AFRO 4000 LOCOMOTIVES : INSPECTION AND VERIFICATION REPORT

REFERENCE	RSR/INSPECTION/AFRO 4000/MWC550	
OPERATOR	PASSENGER RAIL AGENCY OF SOUTH AFRICA (PRASA)	
INSPECTION AND VERIFICATION	INSPECTIONS AND TESTS FOR THE AFRO 4000 LOCOMOTIVES	
INSPECTION AND VERIFICATION DATE	November 2015	
INSPECTION AND TEAM COMPILED	TEAM MEMBERS	SIGNATURE
	MR JOSEPH NETHATHE (Pr. Eng.) (Head: Rolling Stock)	
REVIEWED	MS NTOMBIKAYISE NDAKI (Human Factors Specialist)	
REVIEWED	Dr PEACEMAN SOPAZI (Pr. TechEng) (Head: Technology, Standards & Training)	
REVIEWED	MR BONGANI MQOCO (Pr. TechEng) (Executive: Research & Technical Services)	
RECOMMENDED	MS TSHEPO KGARE (COO)	
APPROVED	MR NKULULEKO POYA (CEO)

Vertical Static Clearance

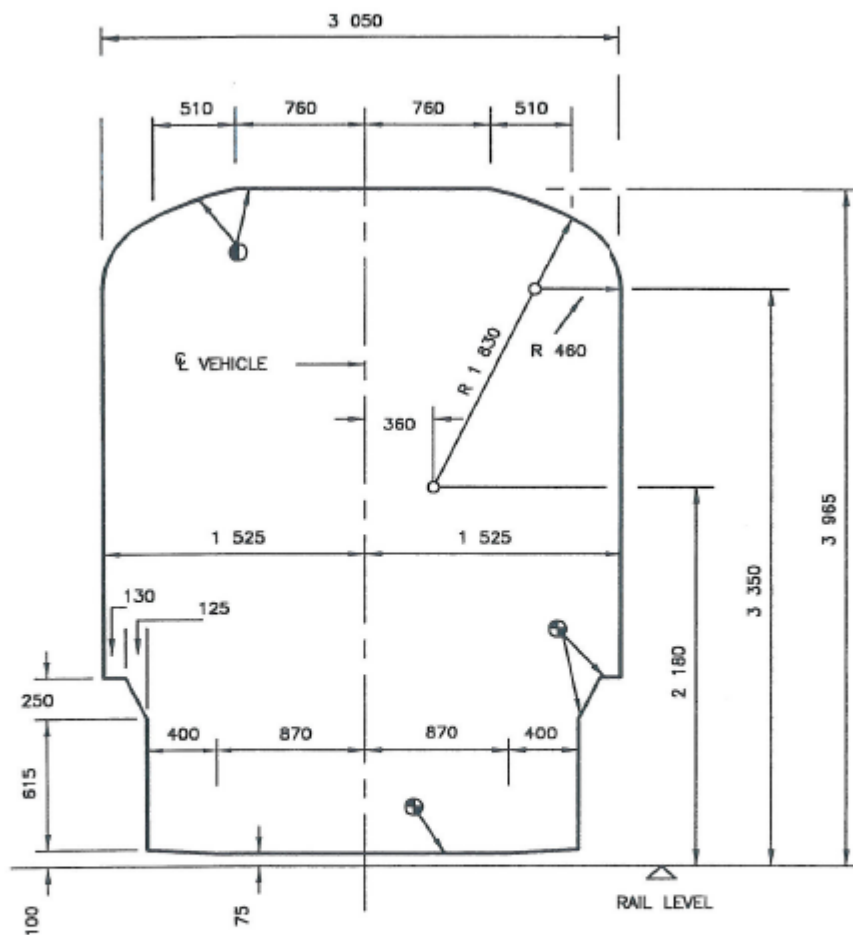
The height of the AFRO 4000 locomotive was measured at 4140mm which is 175mm higher than the track maintenance manual requirement of 3965mm. By exceeding the vehicle gauge, the clearance safety margin between the top of the vehicle and the Overhead Traction Equipment is reduced. Thus, any reduction in height of the TFR contact wire height from its minimum allowed height as a result of tamping activities, will pose a greater risk of contact with this locomotive than any other type of locomotive in the country. This also increases the likelihood of a flashover.

The vehicle static envelope as per the SARCC Manual for Track Maintenance is shown in Appendix D. The maximum allowable height of the vehicle without load and with new wheels and new springs is 3965mm and the allowable width is 3050mm. The Vossloh AFRO 4000 diesel electric locomotive is 4140mm high and 2850mm wide as noted in the descriptive manual of the locomotive, the highest component being the top of the exhaust silencer. The height figure is consistent with the physical measurements which were conducted using a steel tape measure during the inspection of these locomotives. It1 0 0 1 520.18 675.34 Tm1 0 0t 0 1 20095.2insp10 0T35TJo
